Planning Commission Meeting 05/05/22

TECHNICAL MEMORANDUM

TO: Kristy Clark, Grantsville City Planning and Zoning Administrator
FROM: Shay Stark, Contract City Planner
DATE: April 21, 2022 
SUBJECT: Willow Fields PUD Subdivision – Preliminary Application
PROJECT NO.:

PRELIMINARY PLAN - WILLOW FIELDS SUBDIVISION

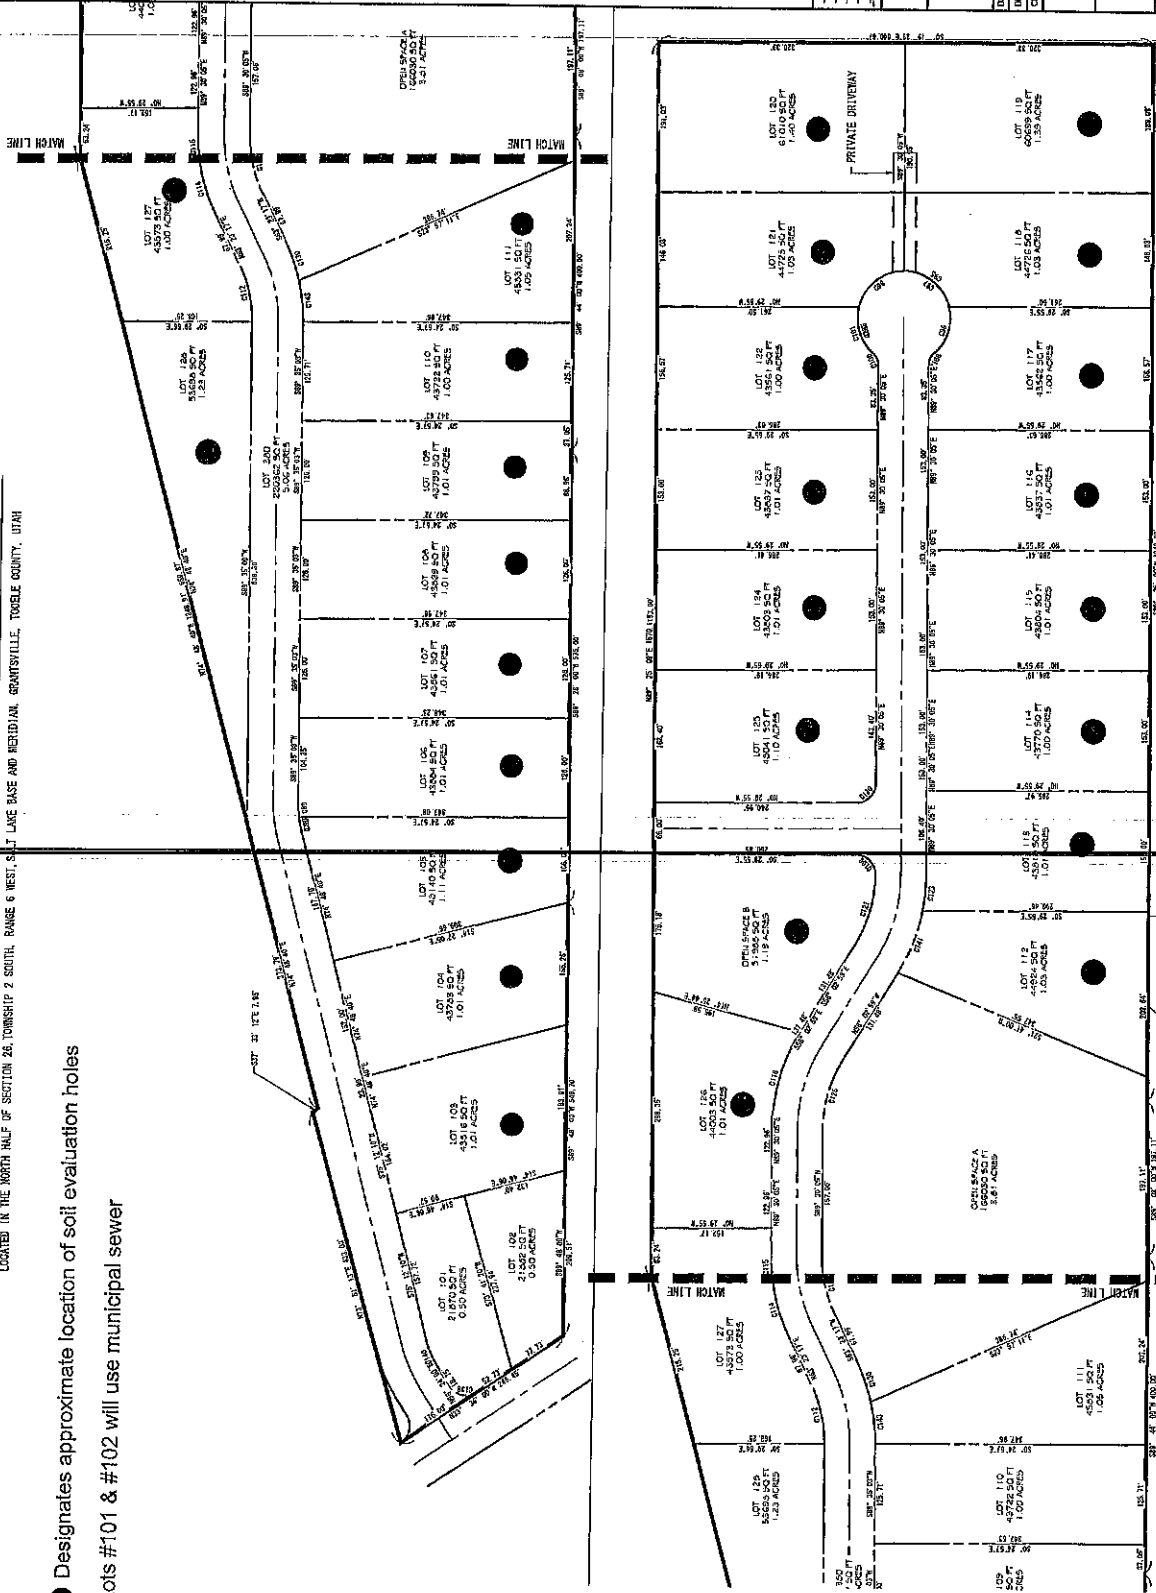
Onsite wastewater disposal systems are the proposed method of wastewater disposal for 26 of the 28 new lots (lots #101 and #102, will be on public sewer) located in the Willow Fields Subdivision. Based on the review of the submitted plans and supportive information, onsite wastewater disposal systems by means of septic tanks and subsurface absorption systems and other department approved systems appears **feasible**. Acceptability of onsite wastewater disposal for each lot will be dependent on strict compliance with the following:

1. The design for each onsite wastewater disposal system must be based on the results of soil exploration and percolation tests conducted on each lot. The results of these tests and detailed plans for each disposal system must be submitted to the Tooele County Health Department for review and evaluation prior to construction and installation. If soil and related tests disclose unfavorable conditions for onsite wastewater and subsurface disposal on certain lots, septic tanks and subsurface absorption systems will not be permitted on these lots.
